SUBJECT: R.E. Ginna Nuclear Power Plant
Docket No. 50-244

Third Supplemental Response to NRC Generic Letter 2004-002, "Potential Impact of Debris Blockage on Emergency Recirculation During Design Basis Accidents at Pressurized-Water Reactors"

REGNPP GL 2004-02 THIRD SUPPLEMENTAL RAI RESPONSE

Figure 15.2: Ginna Strainer Head Loss Test 1 Rep Results

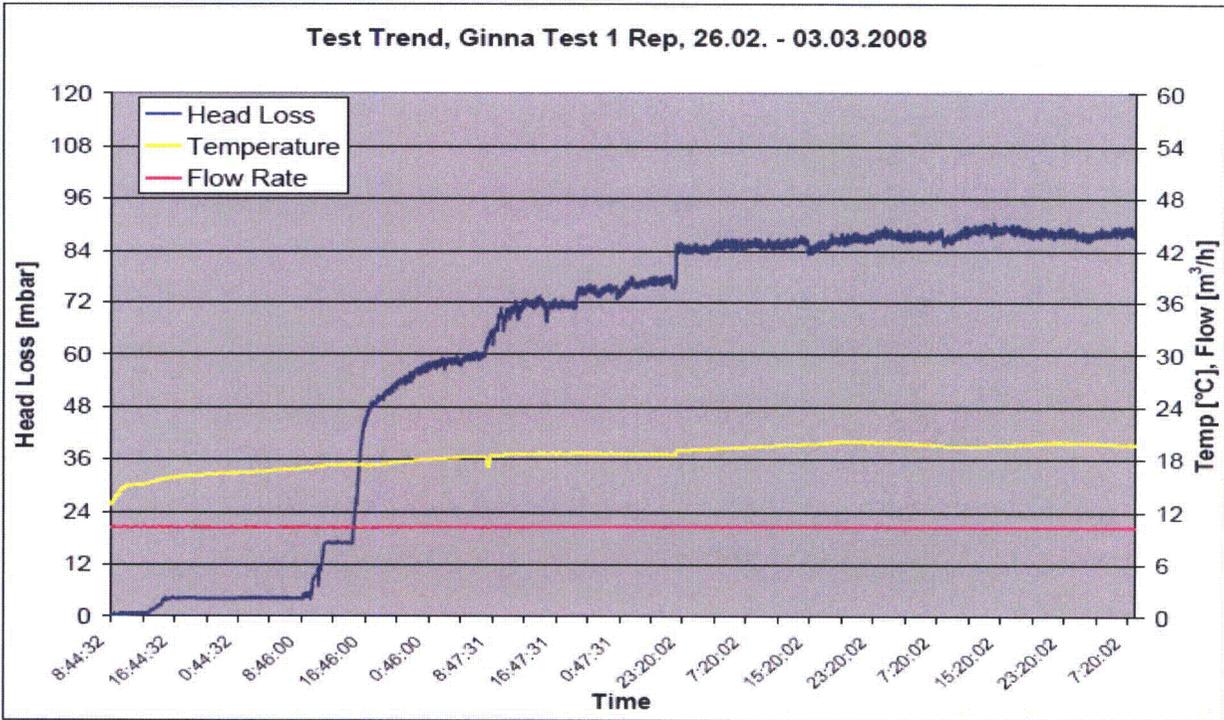
RAI-15: *Please provide the following information as discussed in Enclosure 3 to a letter from the NRC to NEI dated March 28, 2008 (ADAMS Accession No. ML080380214). Specifically, please provide the information requested by item 16.d on page 20 (termination criteria) and items 17.d.i and 17.d.ii on page 21 (test pressure drop curve and an explanation of any extrapolation of data).*

As can be seen in the Test 1 Rep plot of strainer head loss values (Figure 15.2), the head loss was stable for nearly 1 1/2 days prior to the termination of the test. The head loss during this time had minimal variation (± 2 mbar) and the overall trend was steady. As a result, it was determined that the head loss values achieved in Test 1 were valid and bounded the maximum strainer head loss that would be seen in the Ginna containment. The maximum head loss achieved during the Test 1 Rep, adjusted for test tank fluid temperature variations and normalized to 20 °C, was 87.7 mbar [15.4].

Figure 19.1: “Train “A” Failure”

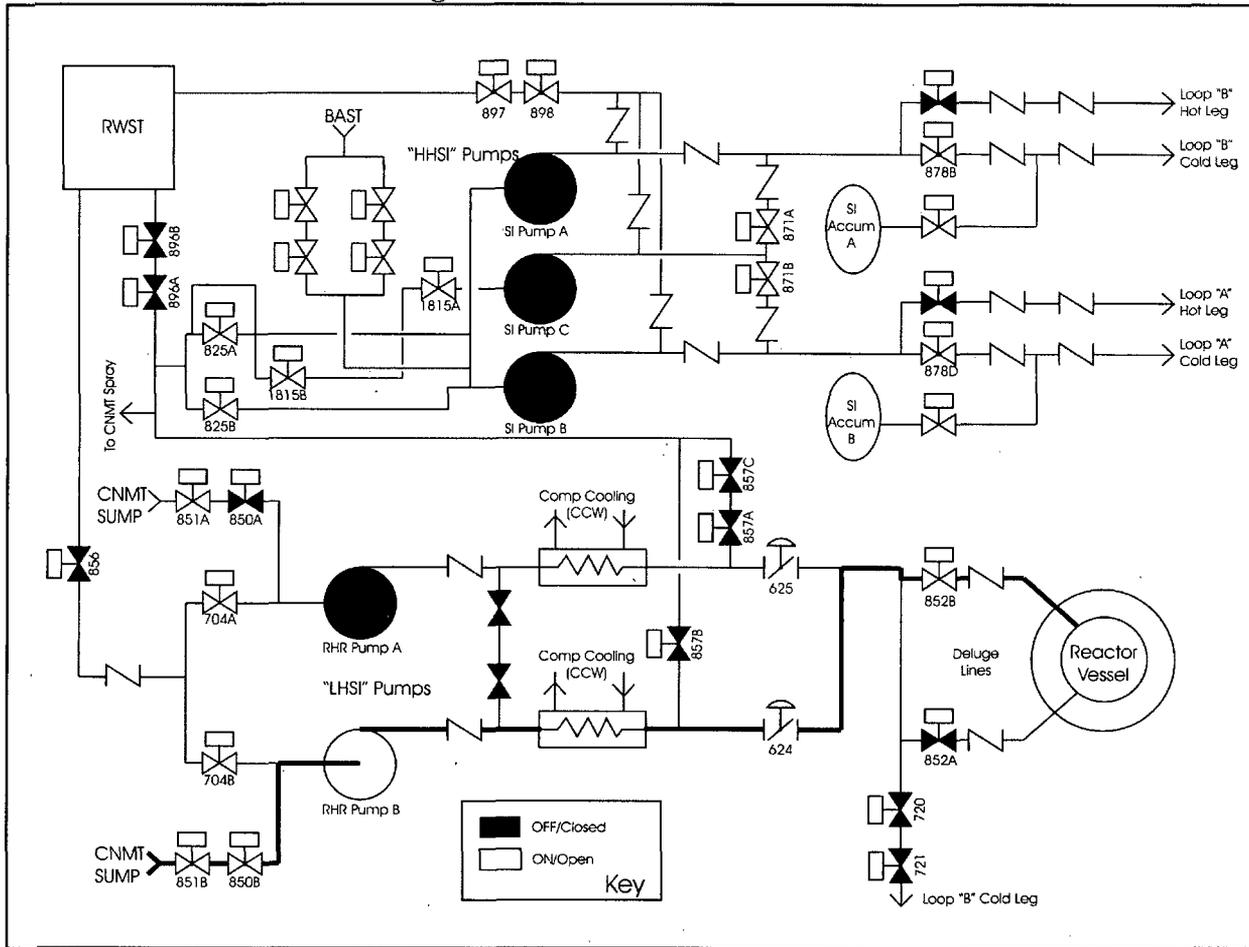
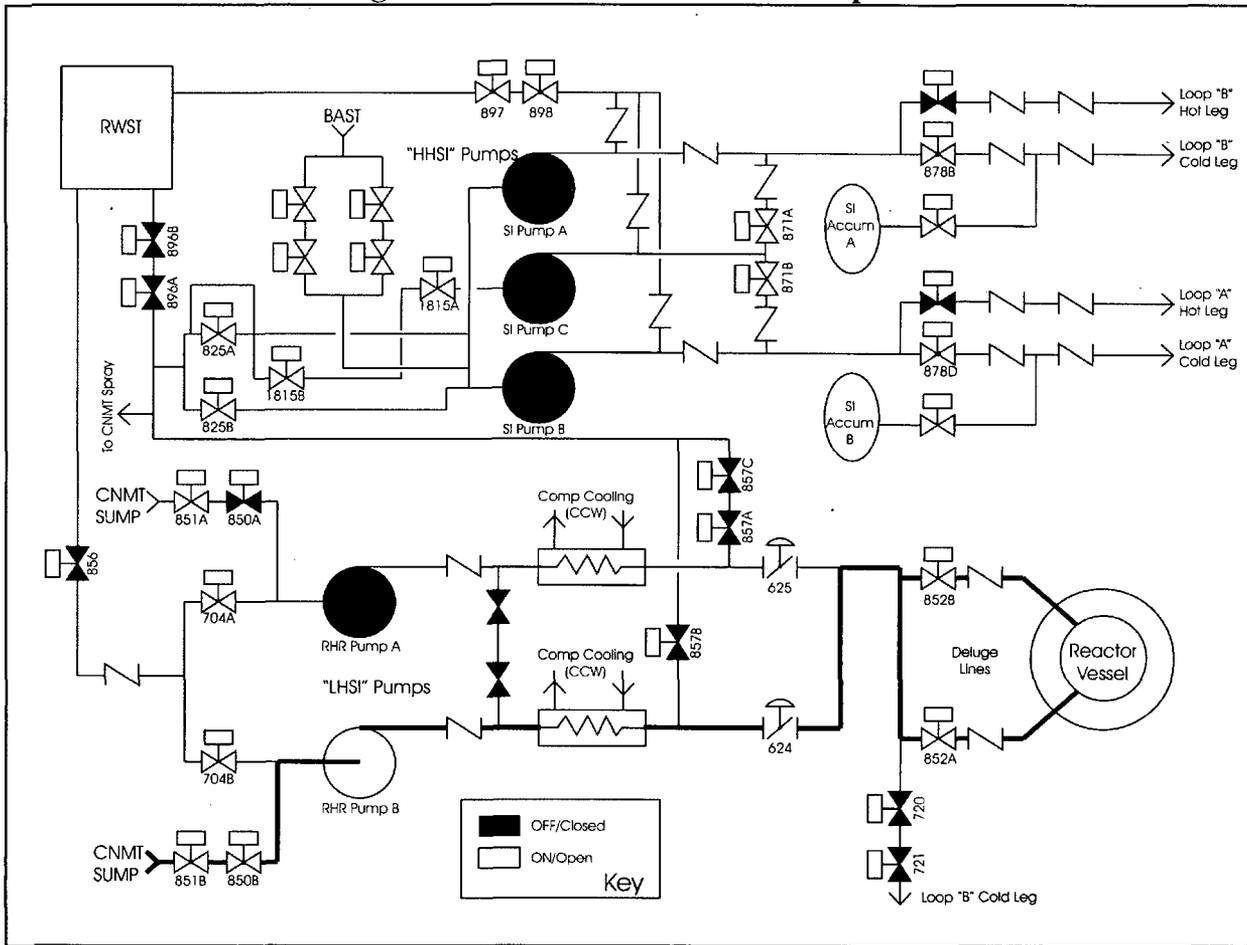
RAI-19: Please provide information that illustrates why there is a difference in the NPSH margin results for the case where “B” RHR pump is operating with a suction line failure (“Suction Line Fails to Open” case) and the case where the “B” RHR pump is operating with a failure of Train A (“Train A Failure” case).

From Figure 19.1, it can be seen that the “B” RHR pump provides flow through only one of the deluge lines when Train “A” fails. However, for the case in which one suction line valve (from the sump) fails to open, the operating RHR pump is providing flow through both deluge lines (see Figure 19.2 below).

Therefore, the "B" RHR pump flow rate will be less in the "Train "A" Failure" case than the "Suction Line Failure" case. From the NPSH calculation [19.1], the flow rate for the "B" RHR pump for the "Suction Line Failure" case is 1671 gpm, whereas, the flow rate for the "B" RHR pump for the "Train "A" Failure" case is 1343 gpm. Since the flow rate is less, the NPSHR will be less resulting in more NPSH margin in the "Train "A" Failure" case than in the "Suction Line Failure" case.
